***INTERNATIONAL PHYSICAL PROTECTION  
ADVISORY SERVICE (IPPAS)***

***Mission Report: Japan***

*16–27 February 2015*

*Prepared for the Nuclear Regulation Authority (NRA) of Japan*

**Figure 37. Inclusion of cyber skills in State DBT.**

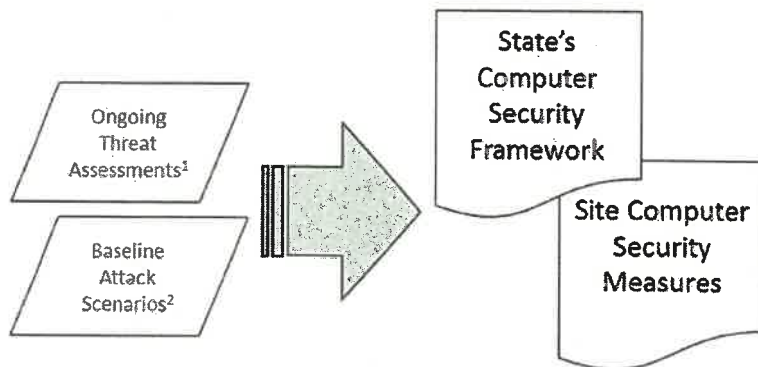
Next, it is also important to develop a longer term view on cyber related threats and risks (Fig. 37). Here, the description of threat needs to be more abstract, not describing actual discovered attack malware but rather describing conceivable adversary scenarios and attack routes and possibly additional cyber-related protection targets that become relevant because of the increase in use of computer systems supporting, for instance, the nuclear safety systems and the physical protection systems.
